Stage 1 Road Safety Audit Report (Feasibility)

**Helmsley House, Bartons Road,
Havant**

**Proposed new residential care home
development.**

(Designer and Auditor Response)

13. Identified Road Safety Audit Matters location plan

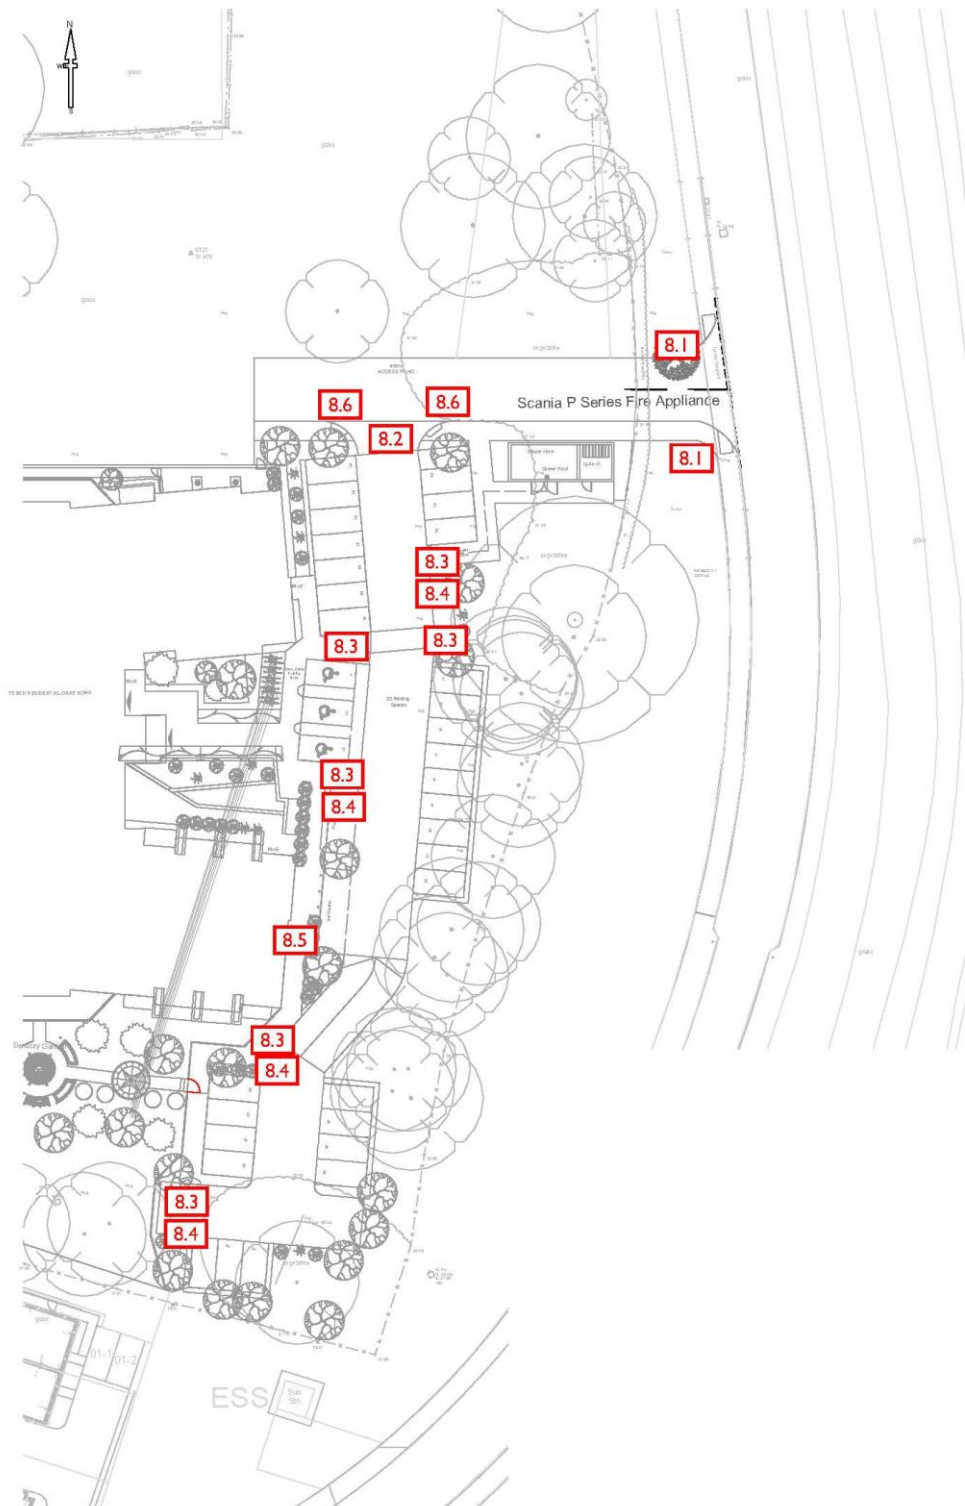
8.1 *Problem* (Item A1.5)	
Location:	Pedestrian crossing across junction with Normandy Way
Summary:	Vegetation located within pedestrian visibility splays obstructing visibility
 There currently is vegetation located along the western side of Normandy Way where the proposed access junction for the residential car development will be located. This vegetation will obstruct pedestrian visibility for pedestrians crossing the access road, reducing their visibility of oncoming vehicles. Remove vegetation from within visibility splays.	
TYPE OF CONFLICT/COLLISION	
Risk of pedestrian injury due to obstructed visibility caused by vegetation.	
RECOMMENDATION	
Remove vegetation from within required visibility splays.

8.2 *Problem* (Item A3.2)	
Location:	Internal junction
Summary:	Visibility splays not detailed
There is an internal junction detailed with no visibility splays shown. Collisions may occur if insufficient visibility is available to oncoming traffic. Ensure suitable visibility splays are detailed.	
TYPE OF CONFLICT/COLLISION	
Risk of collision due to restricted visibility,	
RECOMMENDATION	
Ensure suitable visibility splays are detailed.

8.3 *Problem* (Item A4.2)	
Location:	All internal pedestrian crossing points
Summary:	Visibility splays not detailed or incorrectly detailed
There are a number of pedestrian crossing points detailed on the drawing. All bar one do not have visibility splays detailed. The one crossing that does have visibility splays detailed are shown incorrectly. Pedestrians may be struck by vehicles if there is insufficient visibility at the crossing points to oncoming vehicles. Ensure suitable / correct visibility splays are detailed.	
TYPE OF CONFLICT/COLLISION	
Pedestrians may be struck by vehicles if there is insufficient visibility at the crossing points to oncoming vehicles.	
RECOMMENDATION	
Ensure suitable / correct visibility splays are detailed.

8.4 *Problem* (Item A4.6)	
Location:	Various pedestrian entry points to car park
Summary:	Pedestrians not warned they are entering a shared space
There are dropped kerb entry points to the car park detailed on the drawings. The key on the drawing states 'drop kerb with tactile paving' for the symbols used at these entry points. There are no opposing landing areas at these dropped kerbs, only a shared car park area. Corduroy paving has not been detailed to warn visually impaired pedestrians that they are entering a shared space environment. Visually impaired pedestrians may not take extra care and walk into the path of vehicles. Provide corduroy warning paving at all pedestrian entry points to the car park.	
TYPE OF CONFLICT/COLLISION	
Visually impaired pedestrians may not take extra care and walk into the path of vehicles.	
RECOMMENDATION	
Detail corduroy warning paving instead of tactile paving at all pedestrian entry points to the car park.

8.5 *Problem* (Item A4.6)	
Location:	Steps in footway
Summary:	Trip / fall hazard
There is a set of steps detailed in the footway adjacent to the delivery bay. No handrail warning corduroy paving or street lighting has been detailed at these steps. Visually impaired pedestrians may not be aware of the steps and may trip up or fall down them. Mobility impaired pedestrians may have difficulty climbing the stairs without a handrail and may fall. Provide handrails, warning corduroy paving, and lighting at these steps.	
TYPE OF CONFLICT/COLLISION	
Risk of pedestrian trip or fall from a lack of warning or aid.	
RECOMMENDATION	
Provide handrails, warning corduroy paving, and lighting at these steps.

8.6 *Problem* (Item A4.6)	
Location:	Pedestrian crossing point across internal junction
Summary:	Tactile paving detailed guiding pedestrian incorrectly
There is a pedestrian crossing point shown across the internal junction. The alignment of the tactile paving detailed on the drawing would incorrectly guide pedestrians into the New Access Road and not across side road. Visually impaired pedestrians that rely on this type of paving may be guided into oncoming traffic or have difficulty negotiating over full-height kerbs at the northern verge. Align the tactile paving across the crossing point correctly.	
TYPE OF CONFLICT/COLLISION	
Risk of pedestrian injury from collision of negotiating full-height kerbing.	
RECOMMENDATION	
Align the tactile paving across the crossing point correctly.

8.1	Vegetation located within pedestrian visibility splays obstructing visibility	Vegetation will be cleared prior to commencing works so not an issue

8.2	No junction visibility splay detailed at internal junction	Visibility splay shown	
8.3	No or incorrect pedestrian visibility splays detailed at internal pedestrian crossing points	Pedestrian visibility splays added and amended

8.4	Incorrect paving type detailed at entry to shared space / car park	Paving type and orientation amended	
8.5	No warning corduroy paving, hand rails, or lighting detailed at steps	Corduroy paving shown. Handrails will be provided and the steps will have sufficient lighting but to be covered as part of detailed design phase

8.6	Incorrectly aligned tactile paving	Noted and now corrected

8.1 Agreed

8.2 Agreed

8.3 Noted. Local authority to agree

8.4 Agreed

8.5 Agreed

8.6 Agreed
